SUBJECT: FINAL SAFETY EVALUATION OF THE BWRVIP-234: THERMAL AGING AND
NEUTRON EMBRITTLEMENT EVALUATION OF CAST AUSTENITIC
STAINLESS STEEL FOR BWR INTERNALS (TAC NO. ME5060)

SAFETY EVALUATION OF THE BWRVIP-234 REPORT

FOR BWR INTERNALS (BWRVIP-234)”

Figure 1. Plot of predicted toughness (J-integral value at 2.5 mm crack extension) from BWRVIP-100-A and NUREG/CR-6960 as a function of neutron fluence. The predicted lower-bound toughness of CF-8 due to TE alone is shown at the bottom of the vertical line at dpa = 0 for reference.

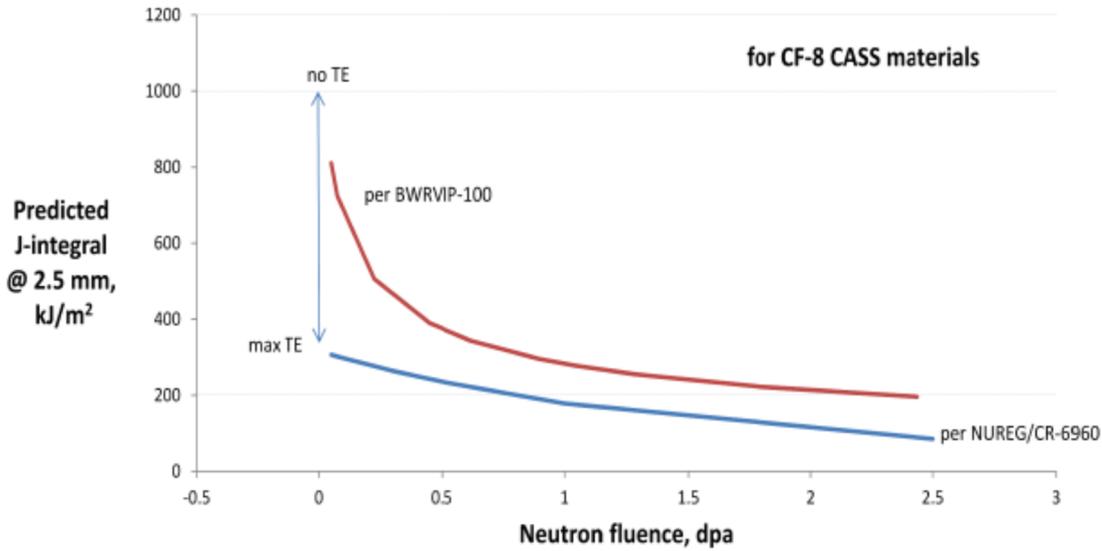
The other method used in the TR to validate the toughness basis for the screening criteria is the BWRVIP-100-A lower bound curve. To determine whether the use of the BWRVIP-100-A model was appropriate for CASS, the NRC staff compared the prediction methodology for fracture toughness from BWRVIP-100-A to that of NUREG/CR-4513, Rev. 1 (Ref. 11) and NUREG/CR-6960 (Ref. 12). The comparison for $J @ 2.5$ is shown in Figure 1 along with the range of predicted J values for unirradiated CF-8 with no thermal embrittlement (TE) and maximum TE (no irradiation) for CF-8 with > 15 percent delta ferrite (Section 3.1.1 of Ref. 11) along with the Ref. 12 predicted toughness trend as a function of fluence. The lower-bound from Ref. 12 is lower, and therefore more conservative than the BWRVIP-100-A predicted toughness. The predicted toughness from Ref. 12 at 0 dpa (no irradiation) is also consistent with the minimum predicted toughness for CF-8 material due to TE alone, represented by the bottom of the vertical line at dpa = 0 on Figure 1. If extrapolated beyond where it was intended to be used, BWRVIP-100-A would predict a much higher toughness at 0 dpa. Based on this comparison, the NRC staff determined that the BWRVIP-100-A methodology maybe be an effective way to account for IE in welded, wrought structures like the core shroud, but the predicted toughness does not consider the effect of TE and therefore would not be a suitable methodology to use in the TR to account for the combined effects of TE + IE on CF-3 and CF-8 materials, especially those with greater than 15 percent but less than 20 percent ferrite (these would pass the screening for TE alone in the Grimes letter).

3.3.1.3 Summary

Because of the concerns expressed above with the methods used to validate the toughness screening criteria in the TR and the response to RAI 9, the NRC staff requested in RAI 9a that the BWRVIP review all available data on fracture toughness of irradiated CASS materials, and the associated uncertainties, and to either revise its methodology to predict the lower-bound toughness of CF-3 and CF-8 materials as a function of neutron fluence, or provide further justification that the methodology in the TR is sufficiently conservative.

Figure A1. Plot of predicted lower-bound J @ 2.5 mm (BWRVIP-100 and NRC staff proposed) vs. neutron fluence. Arrow reflects shift of BWRVIP-100 curve to the left, represents assumed contribution to lower-bound J @ 2.5 mm due to IE.

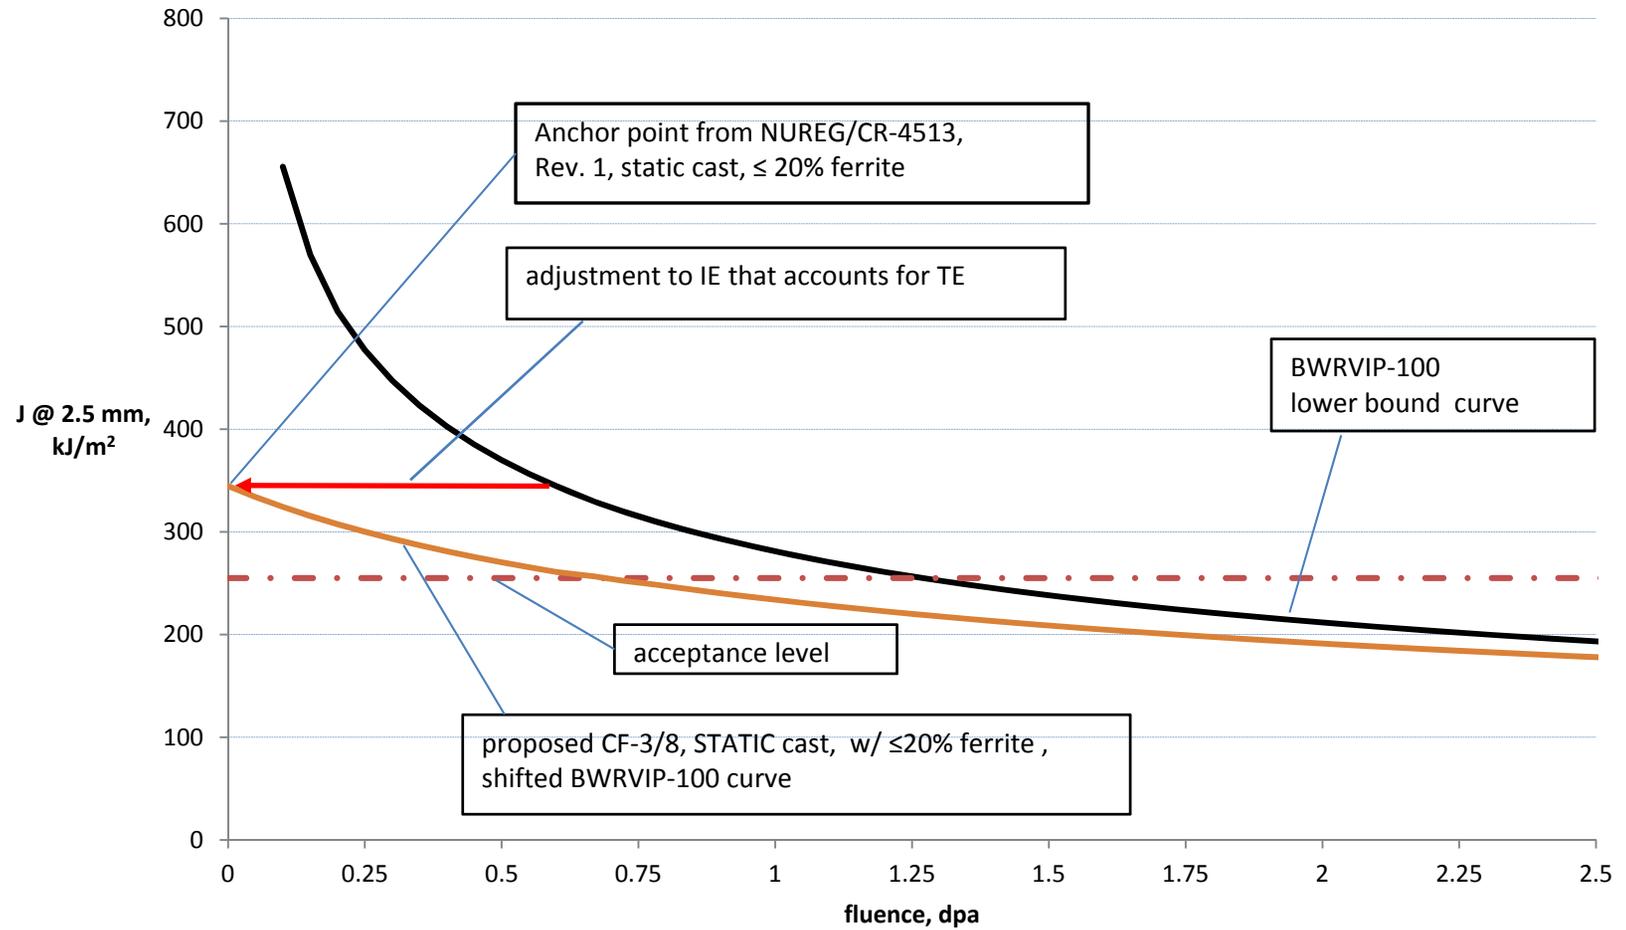
5	Second page of Appendix A, Figure A1	Accuracy	The "< 20 % ferrite" values in Figure A1 need to be changed to "≤ 20% ferrite" to be consistent with Table A1.	Agreed
6	Headers throughout	Clarification	As the SE does not contain any EPRI proprietary information, "Proprietary Information" can be removed from the headers.	Agreed

The screening is based on the estimated, lower bound value of the J integral at 2.5 mm crack extension ($J @ 2.5$). Figure A1 plots the predicted values for $J @ 2.5$ from BWRVIP-100 as a function of neutron fluence along with a new, NRC staff-proposed curve for CF-3 and CF-8 materials where the $J @ 2.5$ for 0 dpa is set equal to the lower-bound $J @ 2.5$ value for CF-8 with 15 to 25 percent ferrite from NUREG/CR-4513, Rev. 1. CF-8 material with a calculated ferrite content ≤ 20 percent would not be considered susceptible to TE alone using the Grimes letter. The remainder of the proposed curve is obtained by shifting the BWRVIP-100 curve for $J @ 2.5$ to the left until it intersects the vertical axis. In this way, the proposed curve takes full account for the saturated lower bound toughness for TE used in the development of the Grimes letter and incorporates an additional margin to account for the further reduction in fracture toughness due to IE. Given that there is no evidence of a synergistic effect, this combined effect is acceptable to the NRC staff. With this method, the lower-bound estimate of $J @ 2.5$ for static-cast CF-8 with ≤ 20 percent ferrite equals the acceptance level at about 0.7 dpa.

Furthermore, the NRC staff notes that the discussion in BWRVIP-234 is applicable to an acceptance criteria where the $J @ 2.5$ is 255 kJ/m² (appropriate for pressure-boundary components like the reactor coolant system) yet the discussion in BWRVIP 2015-025, Attachment C, "Reactor Vessel CASS flaw tolerance," demonstrates that the loading for typical RVI components results in an applied J-integral far below the $J @ 2.5$ of 255 kJ/m² level. Furthermore, the NRC staff notes that EPRI report TR-112718^c calculates applied J values for three different generic models that were designed to simulate RVI components. Both Attachment C and EPRI TR-112718 come to the similar conclusion that the crack driving forces in RVI components are much lower than the current acceptance criteria of $J @ 2.5$ is 255 kJ/m². These results suggest that there is a significant margin between the maximum applied J for RVIs (in Attachment C that would be 83 kJ/m²) and either acceptance criteria (255 or 200 kJ/m²). With an acceptance criteria of 200 kJ/m², the lower-bound estimate of $J @ 2.5$ for static-cast CF-8 with between ≤ 20 percent ferrite would exceed the acceptance level up to about 1.7 dpa.
